# UNITED STATES PATENT AND TRADEMARK OFFICE

APPLICATION NO.	FILING DATE	FIRST NAMED INVENTOR	ATTORNEY DOCKET NO.	CONFIRMATION NO.
10/729,679	12/05/2003	Kenneth M. Sprouse	7784-000644	3173
27572	7590	02/02/2006	EXAMINER	
HARNES, DICKEY & PIERCE, P.L.C. P.O. BOX 828 BLOOMFIELD HILLS, MI 48303			KOCZO JR, MICHAEL	
			ART UNIT	PAPER NUMBER
			3746

<b>Office Action Summary</b>	<b>Application No.</b> 10/729,679	<b>Applicant(s)</b> SPOUSE ET AL	
	<b>Examiner</b> Michael Koczo, Jr.	<b>Art Unit</b> 3746

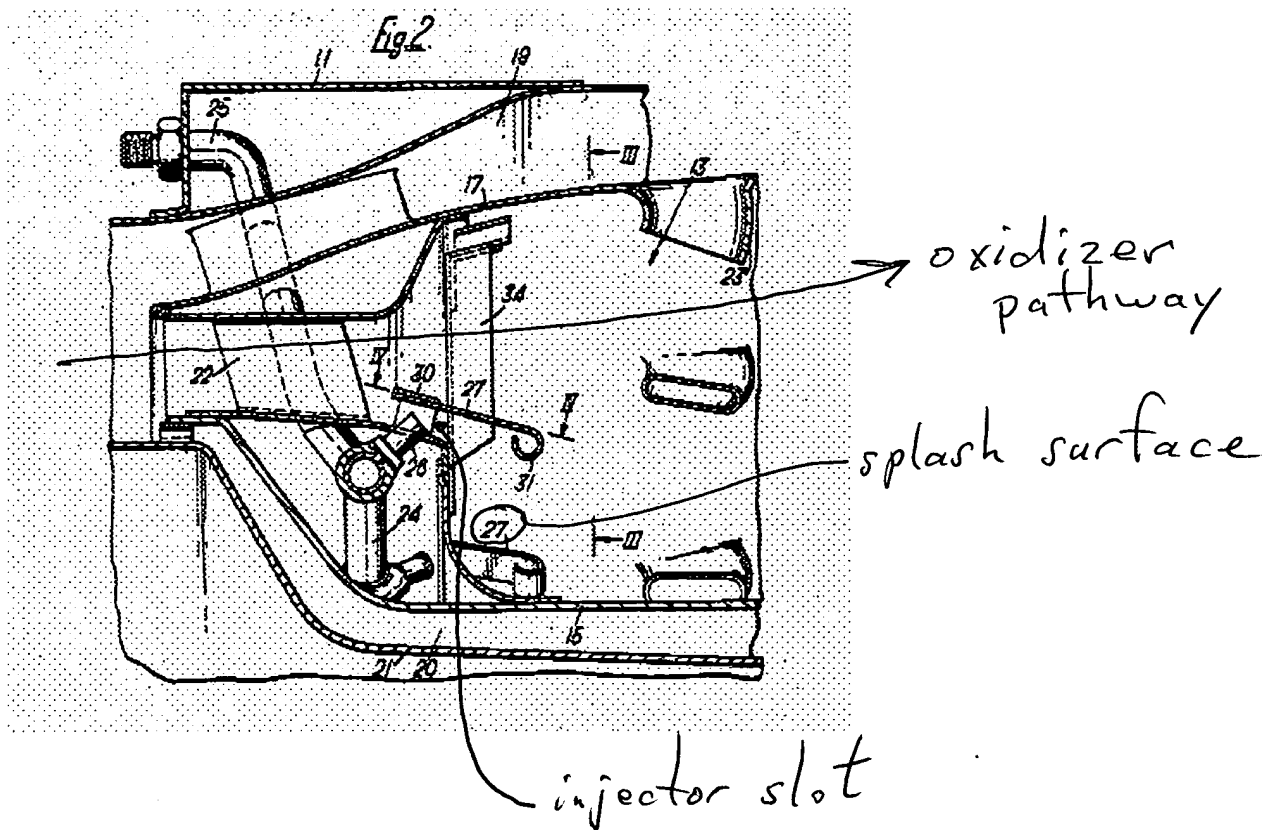
Claims 12, 13, 15, 16, 17, 22, 23, 24 and 25 are rejected under 35 U.S.C. 103(a) as being unpatentable over Carlisle in view of Amann. Carlisle discloses the invention substantially as claimed. However, Carlisle does not disclose a preheat section to heat the oxidizer. Amann discloses that it is known to use a regenerator 7 to preheat the oxidizer in order to recover energy which would otherwise be wasted. In view of this teaching, it would have been obvious to

provide the gas turbine of Carlisle with a recuperator for heating the oxidizer. Figure 2 of Carlisle is reproduced below with the relevant portions labeled with the corresponding claim elements. Regarding claims 12 and 22, the “wherein” clauses merely recite a desired result. Whether or not the fuel substantially mixes with the oxidizer from the oxidizer pathway prior to combusting is dependent on operating parameters, such as the flow rates, pressures and temperatures of the fuel and air, which are beyond the scope of the claims. The structure of Carlisle is furthermore inherently capable of mixing the fuel with the stream of oxidizer before any portion of the fuel combusts given the right operating parameters. Regarding claims 23 to 25, these claims merely recite the intended use of the injector and do not define structurally over the injector of Carlisle. The injector of Carlisle is inherently capable of injecting the different fuels as recited in claim 25.

Applicant argues that Carlisle does not teach an injector slot near an oxidizer pathway. Referring to figure 2 of Carlisle, the injector slot is adjacent the oxidizer pathway. This is readable as an injector slot near the oxidizer pathway.

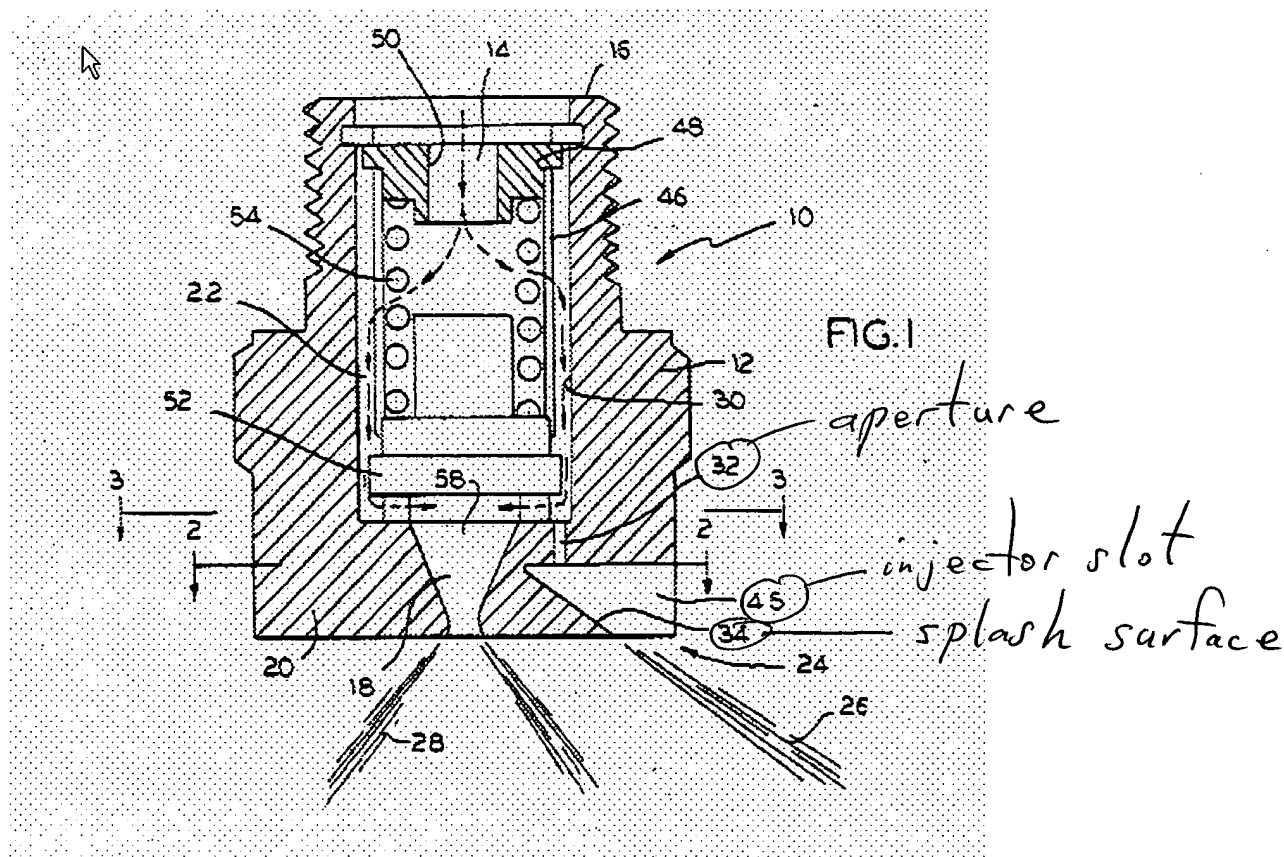
Claims 12, 13, 15, 16, 17, 22, 23, 24 and 25 are also rejected under 35 U.S.C. 103(a) as being unpatentable over Shekelton et al. in view of Amann. Shekelton et al. disclose the invention substantially as claimed. However, Shekelton et al. do not disclose a preheat section to heat the oxidizer. Amann discloses that it is known to use a regenerator 7 to preheat the oxidizer in order to recover energy which would otherwise be wasted. In view of this teaching, it would have been obvious to provide the gas turbine of Shekelton et al. with a recuperator for heating the oxidizer. Figure 1 of Shekelton et al. is reproduced below with the relevant portions labeled with the corresponding claim elements. Regarding claims 12 and 22, the “wherein” clauses merely recite a desired result. Whether or not the fuel substantially mixes with the oxidizer from

the oxidizer pathway prior to combustor is dependent on operating parameters, such as the flow rates, pressures and temperatures of the fuel and air, which are beyond the scope of the claims.

The structure of Carlisle is furthermore inherently capable of mixing the fuel with the stream of oxidizer before any portion of the fuel combusts. Regarding claims 23 to 25, these claims merely recite the intended use of the injector and do not define structurally over the injector of Shekelton et al. The injector of Shekelton et al. is inherently capable of injecting different fuels.

Applicant argues that Shekelton et al do not teach an injector slot near an oxidizer pathway. Any flow of oxidizer is readable as an oxidizer pathway. Referring to figures 1 and 4 of Shekelton et al, it can be seen that the oxidizer flows adjacent the injector nozzles. That is, the injector slot 45 is near the oxidizer pathway.
